TECHNICAL INFORMATION

89793

Subject ▶ Change of Contact Arm

For Models ▶ LS1016FL, LS1016L, LS1216FL, LS1216L

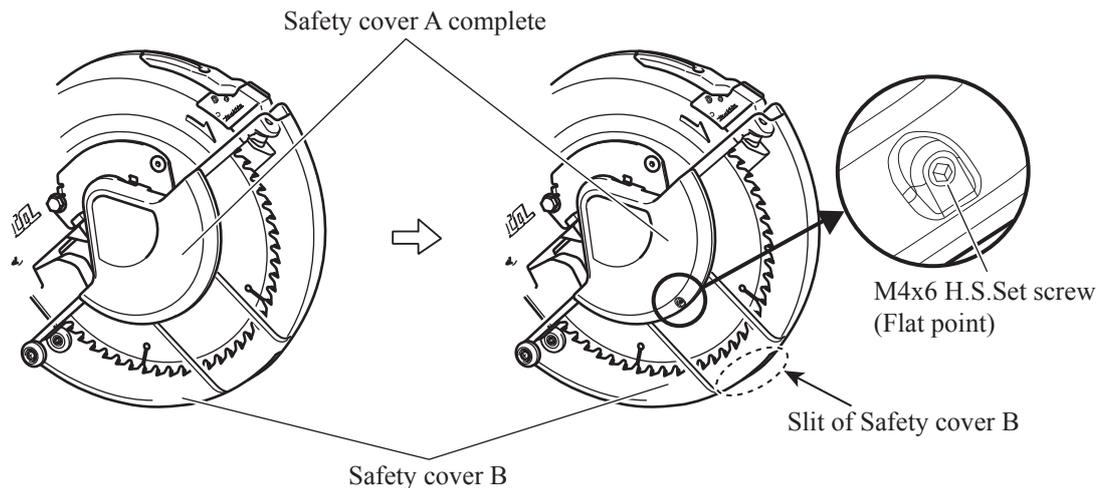
Description ▶ Safety cover A complete has been changed.
M4x6 H.S.Set screw (Flat point) has been added to the new Safety cover A complete.
The position of a slit of Safety cover B can be adjusted.

Note: First, align the head of M4x6 H.S.Set screw with the outer surface of Safety cover A complete.
When a laser beam can not pass through the slit of Safety cover B at 45° left bevel cut position of Blade,
tighten the M4x6 H.S.Set screw to the position that the laser beam can pass through the slit.
